REPORT ON PROPOSALS

THE WATER EFFICIENCY AND SANITATION STANDARD
TECHNICAL COMMITTEE REPORT ON PROPOSALS FOR
PUBLIC REVIEW AND COMMENT

These proposals were presented to the WE•Stand Technical Committee members who met in Ontario, California on June 22-23, 2022.

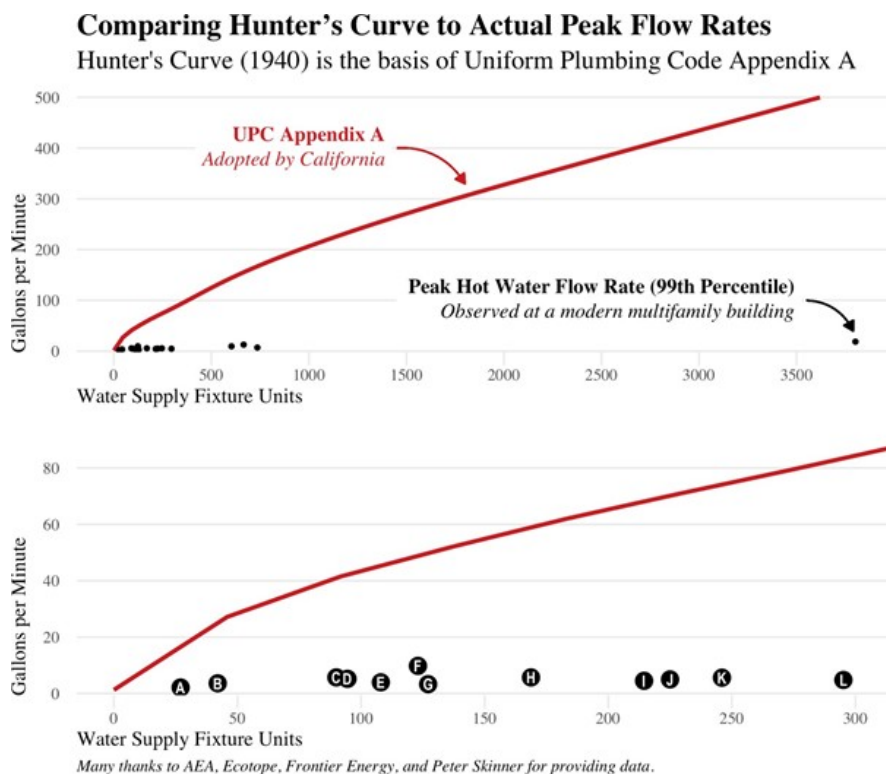
Figure 1 from the Petition provides a comparison of Actual Peak Flow Rates to calculated rates using the Hunter’s Curve. The figure underscores that the standard practice – based on the Hunter’s curve – overestimates the peak flow rates when compared to use with plumbing fixtures and appliances that have been in buildings since the Energy Policy Act of 1992 went into effect the mid-1990s.

Comparing Design Predictions to Actual Peak Flow Rates

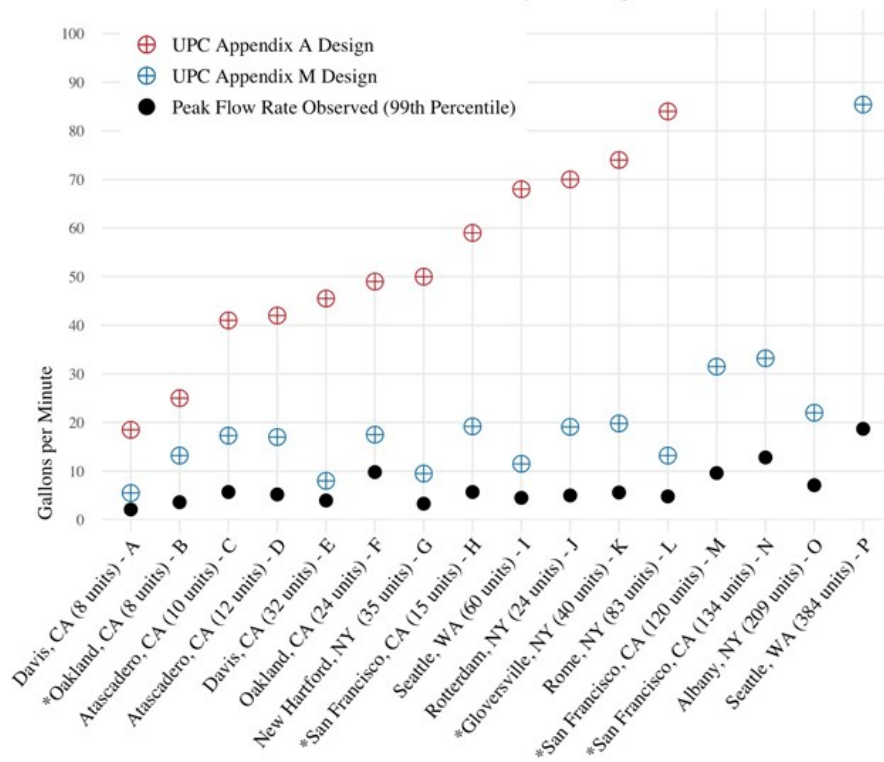
Figure 2 from the Petition compares the monitored data from the 16 multifamily buildings to the peak water demand estimates based on UPC Appendix M. The comparison shows that Water Demand Calculator provides a conservative approach to estimate peak water flow rates, providing a margin of safety at least 1.8 times the measured data in multifamily buildings.

Figure 1 - Silicon Check Valve (New)

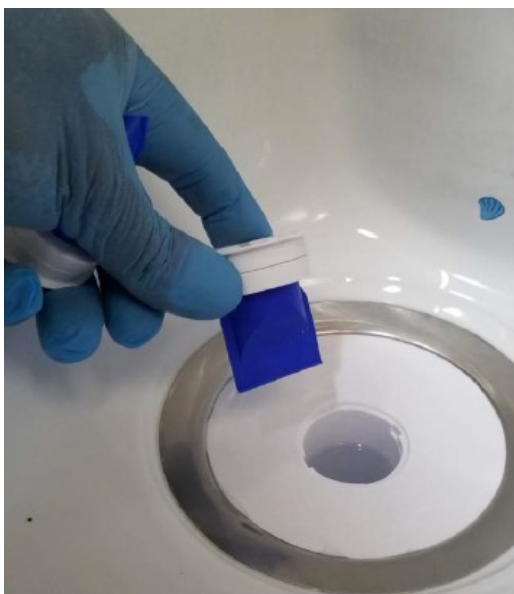
The proposed language allows a greater selection of backflow traps to be used. Waterless urinals have seen great success in silicon mechanical backflow seals. (See Figure 1 and Figure 2 below.) However, under the current plumbing code, a mechanical backflow device or check valve can not be used without a liquid "P-trap" or sump.

As documented in 2022 CalTrans Waterless Urinal Study by Dr. Harold Leverenz, UC-Davis, waterless urinals that rely upon a liquid P-trap or sump are far more likely to foul and clog faster than a mechanical check valve that does not rely upon liquid for a backflow seal. (See Figure 3 and Figure 4 below.)

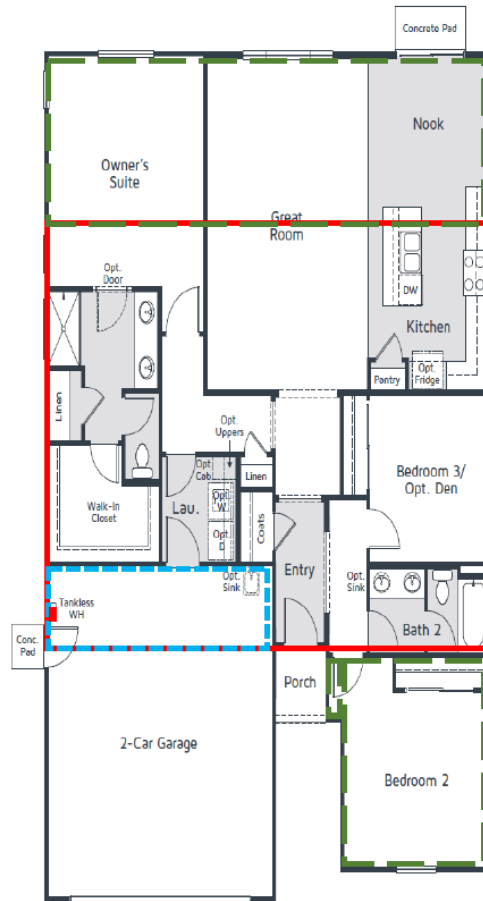
This "maximum hot water system ratio" is intended to promote efficient floor plan layouts to limit heating energy and water-use. Inefficient fixture locations will have long hot water wait times, resulting in greater water use and heating energy with no benefit to the user. The values of 60% and 30% here are achievable in common fixture arrangements in most dwellings, while prohibiting the most inefficient layouts.

In the below example, the red rectangle is drawn to match the boundary of where all fixtures are located. The green rectangles represent the portions of the dwelling where there are no fixtures located. When accounting for the red area with respect to the total of the green and red areas, it can be seen that 67% of this dwelling is covered by the red area, meaning plumbing fixtures are spread throughout 67% of the dwelling.

CHART C 101.1(1)

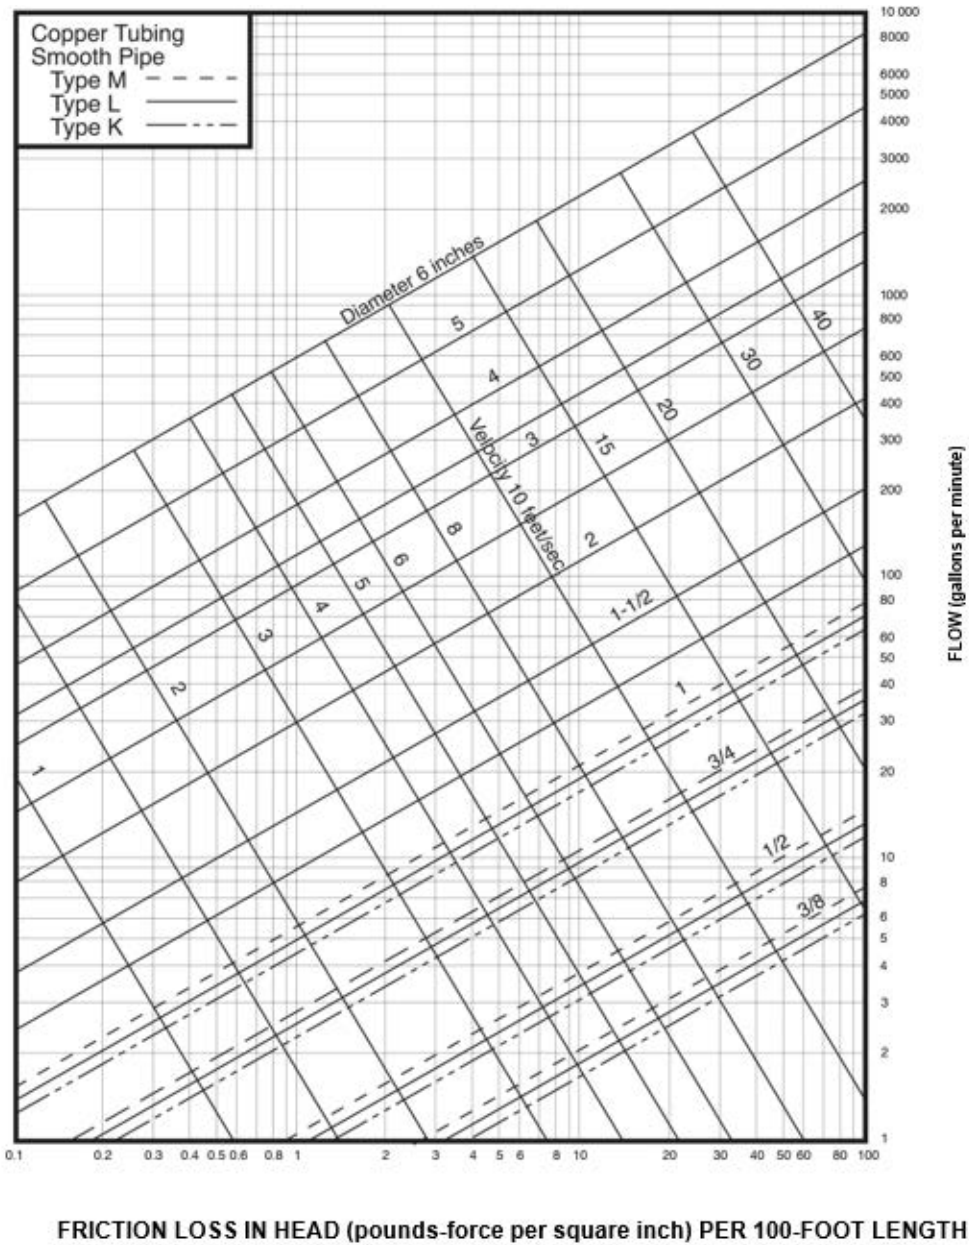
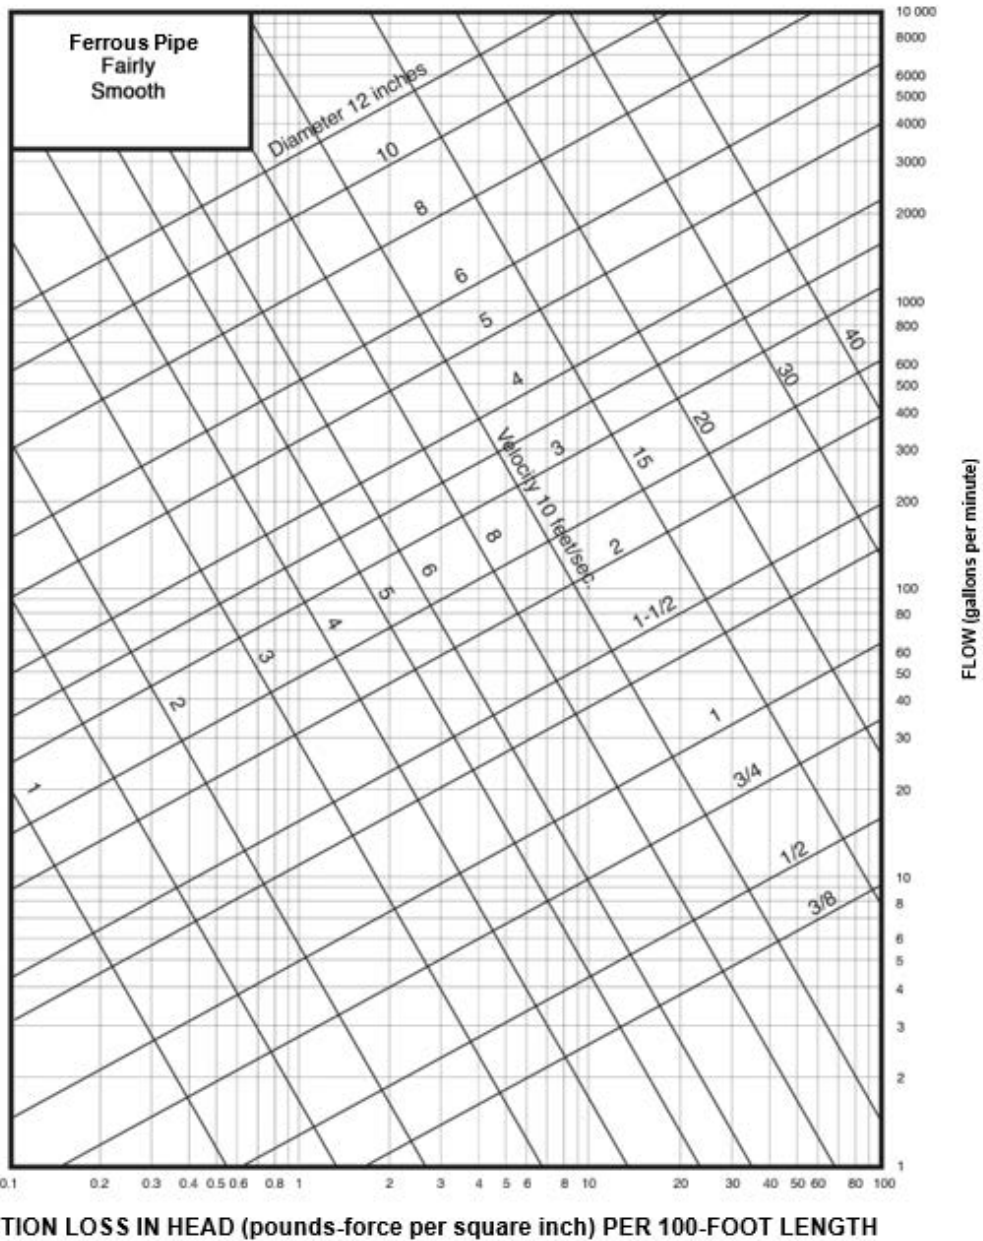
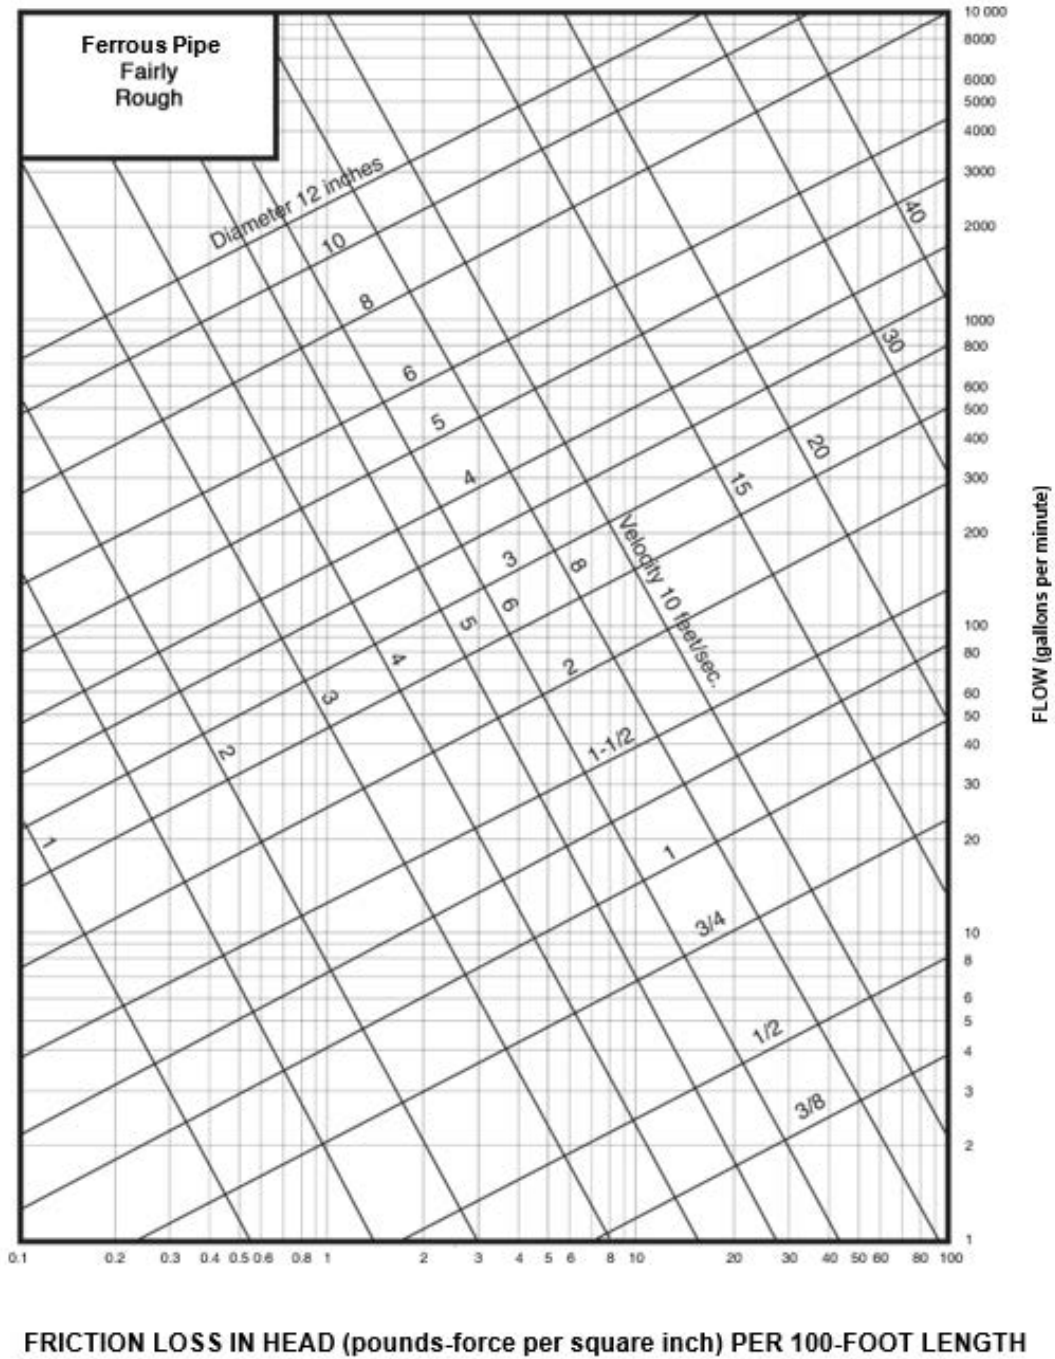
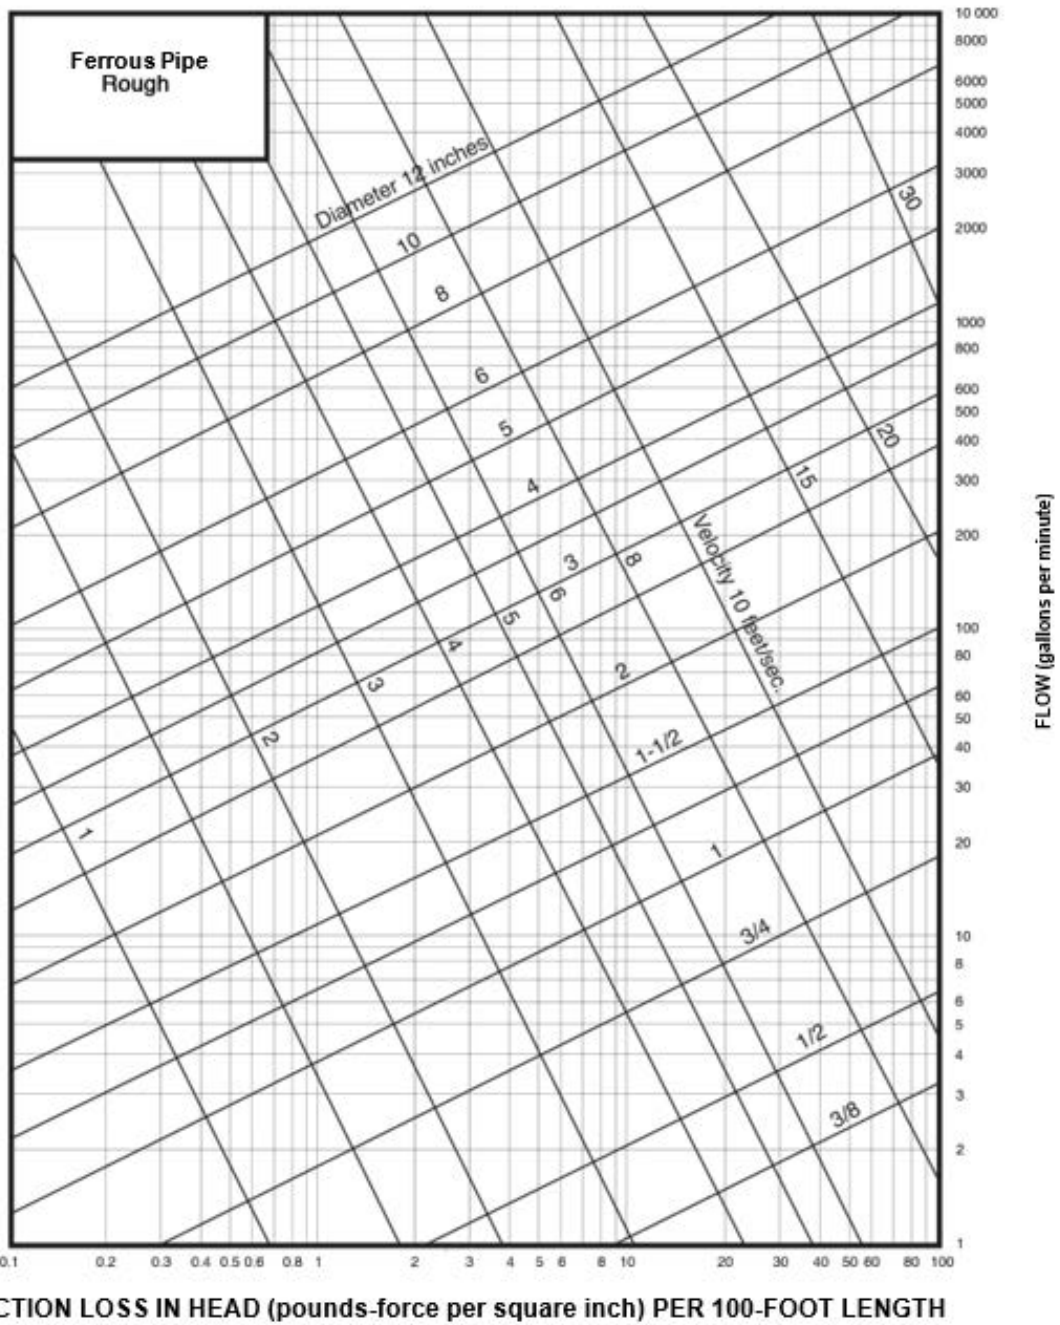
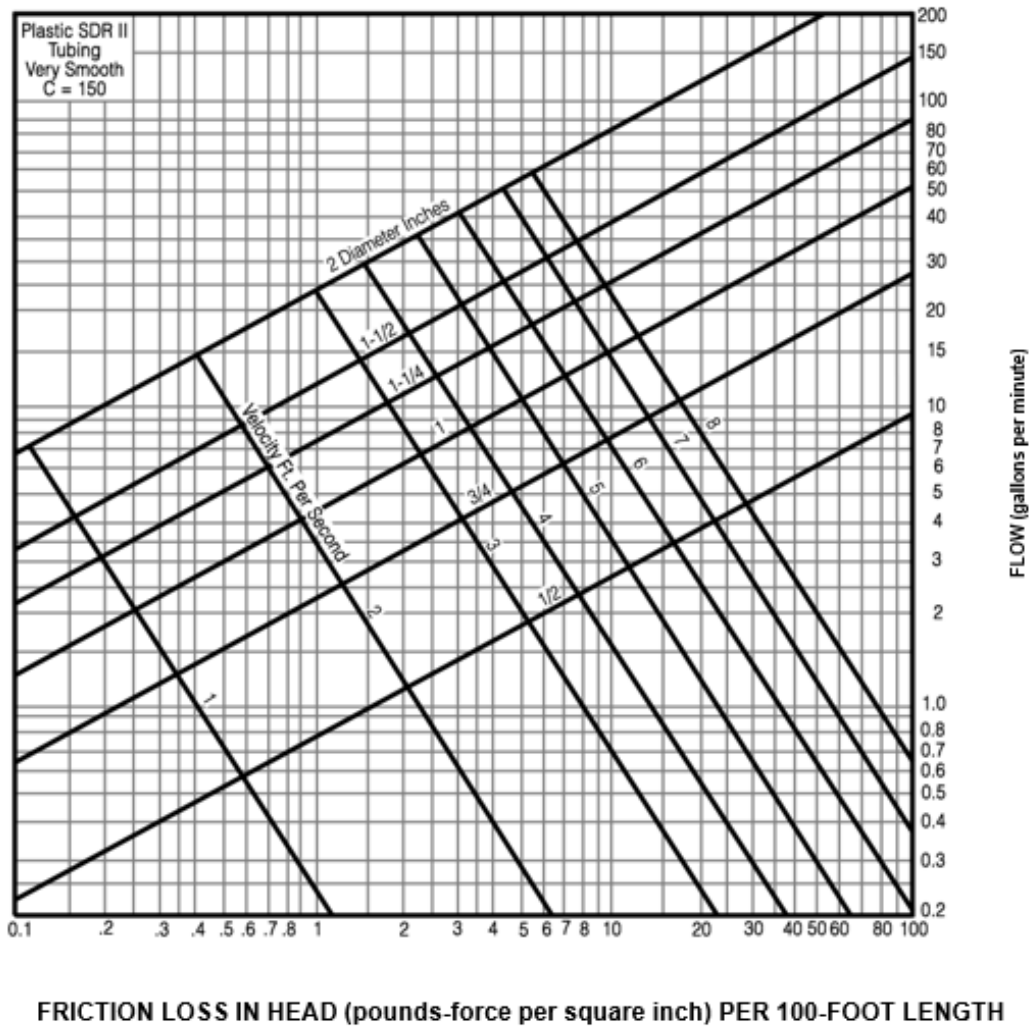
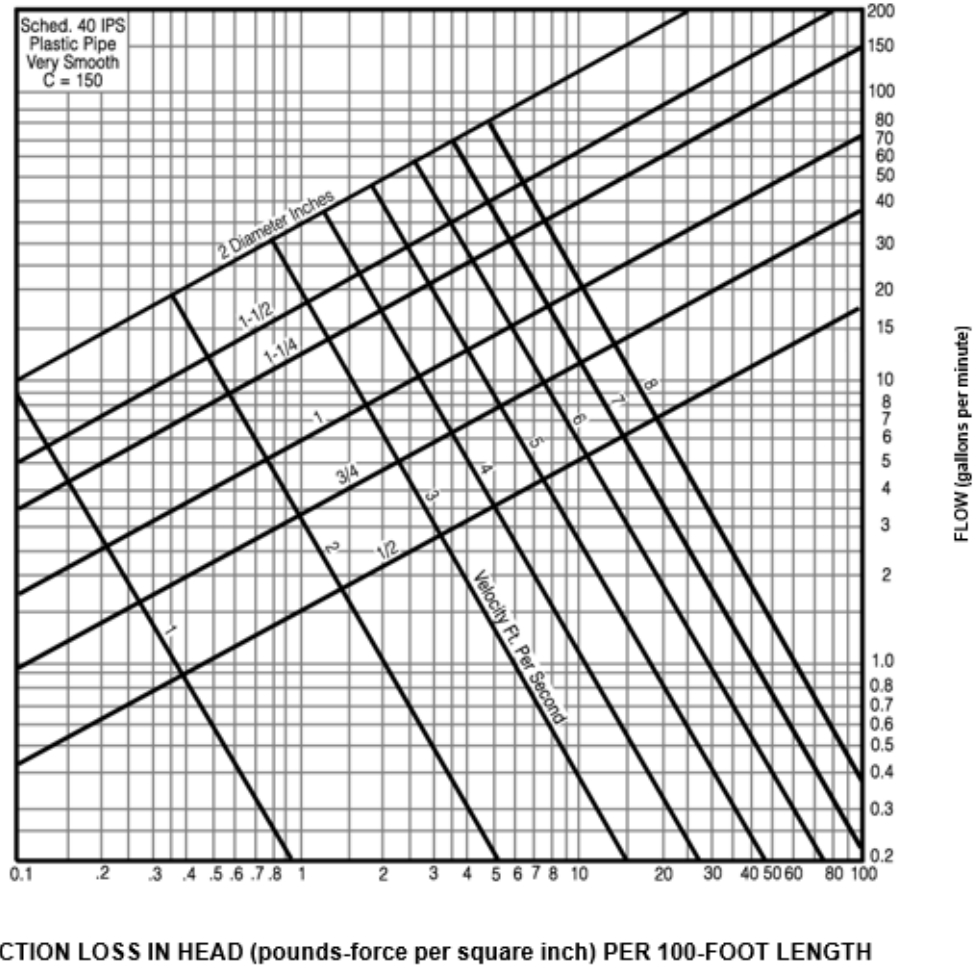
Based on the actions taken on Item #074, Item #123 is also being rejected. Chart C101.1(1) through Chart C101.1(9) from this proposal should be relocated to Chapter 5. This relocation would prevent conflict where Appendix C is not adopted by the jurisdiction and ensure applicable tools are provided for utilizing the WDC. The Technical Committee has identified this as the only reason for rejection and requests this change be made via public comment.
